**PLANNED UNIT DEVELOPMENT
STAFF REPORT****Date: March 6, 2014****DEVELOPMENT NAME**

Westwood Plaza, LLC

LOCATION7765 Airport Boulevard
(Southeast corner of Airport Boulevard and Schillinger
Road South, extending to the North side of Thomas Road)**CITY COUNCIL
DISTRICT**

CONTEMPLATED USEPlanned Unit Development Approval to amend a
previously approved Planned Unit Development to allow shared access across multiple lots and
multiple buildings on a single building site.**TIME SCHEDULE
FOR DEVELOPMENT**

SITE PLAN

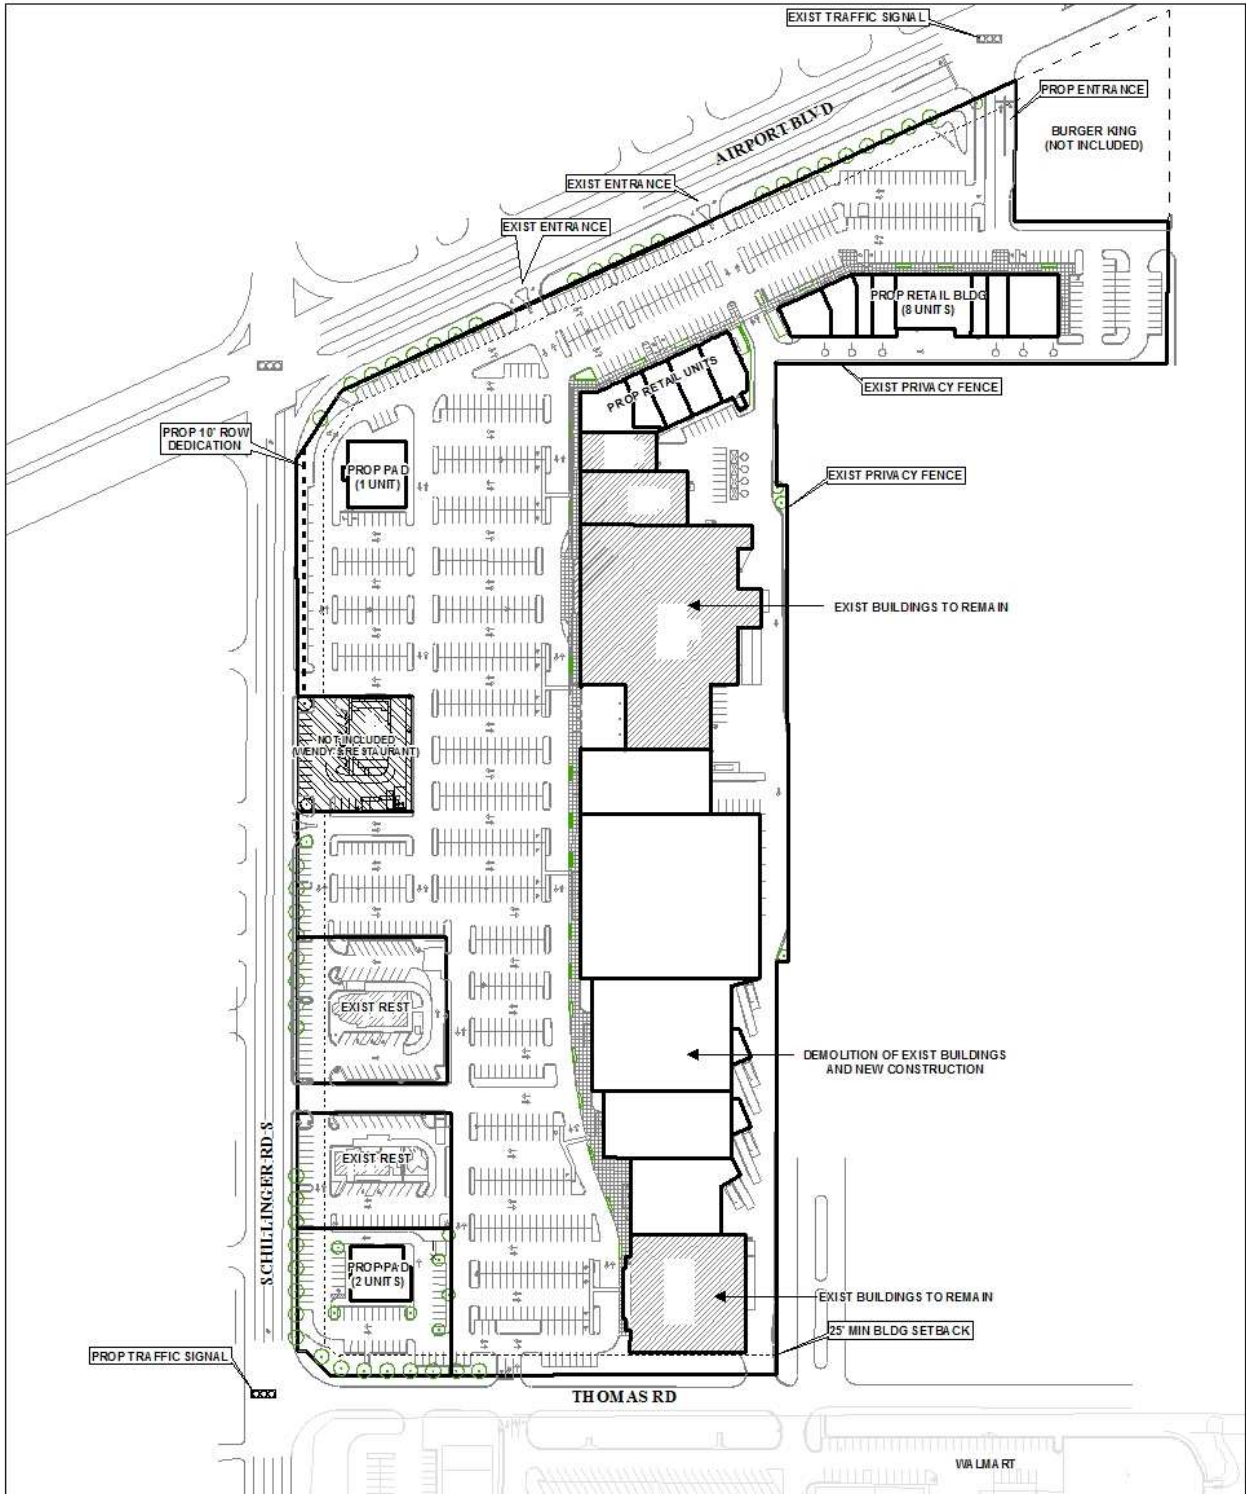
The traffic impact study will need to be updated for this site, since the proposed building area has increased and additional access is planned on Victoria Drive. The updated study will need to clearly address the access to the existing Alverson Road traffic signal. The submitted site plan does not illustrate the adjacent Burger King site, however the landscape plan does. Access to the traffic signal will need to be maintained for the adjacent site, and changes to the existing adjacent site driveways will need to be incorporated. Traffic Engineering approval of this site is contingent upon the construction by the developer/owner of all improvements identified in the study. It should be noted that the improvements include the installation of a traffic signal on Schillinger Road at Thomas Road. Installation of this traffic signal is contingent upon the removal of the traffic signal at Schillinger Road/Glider Road. Design plans for all improvements within the public right-of-way must be approved by Engineering and Traffic Engineering. Upon completion of the Access Management Study underway for the Schillinger Road corridor, additional restrictions may be implemented. Driveway number, size, location and design to be approved by Traffic Engineering and conform to AASHTO standards. All on-site parking, including ADA handicap spaces, shall meet the minimum standards as defined in Section 64-6 of the City's Zoning Ordinance.

It should be pointed out that staff added the parking numbers provided on the site plan, and came up with a different number of parking spaces than noted in the table on the site plan, 1,160 parking spaces, and the 1,210 parking spaces listed on the tree and parking calculations sheet provided by the applicant (*it is estimated that 1,051 parking spaces are required based upon the proposed tenant mix*). If the number of parking spaces and tenant areas labeled on the plan are inaccurate, and on the landscape calculations sheet, both should be revised to list the correct number of spaces and tenant areas.

A note on the site plan states that a Sidewalk Waiver will be requested along both Airport Boulevard, Schillinger Road and Thomas Road (but not Victoria Drive, perhaps by oversight), however, an application was not included for consideration with the PUD application. A Sidewalk Waiver application should be submitted prior to any request for permits related to new construction.

- Administration Ordinance (Mobile City Code, Chapter 57, Article VIII). 2. Plan Sheet L-100 shows proposed work on the existing Burger King site that includes parking spaces to be located within the Airport Blvd ROW. These need to be removed from the ROW, or the applicant needs to obtain a Non-Utility ROW Use Agreement For any parking and/or maneuvering spaces within the Public ROW. 3. Any and all proposed land disturbing activity will need to be in conformance with the Storm Water Management and Flood Control Ordinance (Mobile City Code, Chapter 17, Ordinance #65-007 & #65-045); the City of Mobile, Alabama Flood Plain Management Plan (1984); and, the Rules For Erosion and Sedimentation Control and Storm Water Runoff Control. 4. Each Lot Owner shall be required to submit a Land Disturbance Permit application for any proposed land disturbing activity. A complete set of construction plans including, but not limited to, drainage, utilities, grading, storm water detention systems, paving, and all above ground structures, will need to be included with the Land Disturbance permit. This Permit must be submitted, approved, and issued prior to beginning any of the construction work. 5. Add a note to the PUD Site Plan stating that the proposed development must comply with all Engineering Department Policy Letters. 6. Victoria Drive will need to be improved to a street standard as approved by the City Engineer and Traffic Engineer based on the traffic study (24' curb and gutter section minimum). 7. Revise Landscape Area "A" detail to keep any "pond" areas outside of the Public ROW. 8. All dumpsters, including outside compactors, must meet the requirements of Engineering Policy Letter dated 5-13-2009 related to car washes and dumpster pads by isolating, collecting, and transporting storm water runoff to the Sanitary Sewer system onsite.);*

- 9) Donation of 10 overstory trees to the tree bank, as agreed to by the applicant at the August 8, 2013 Planning Commission meeting;
- 10) Revision of parking space quantities to reflect what is actually depicted on the plans, including revision of calculations for tree and landscape compliance;

- 11) Provision of a revised PUD site plan depicting any changes required by departmental or Planning Commission revisions prior to the request for new construction permits; and
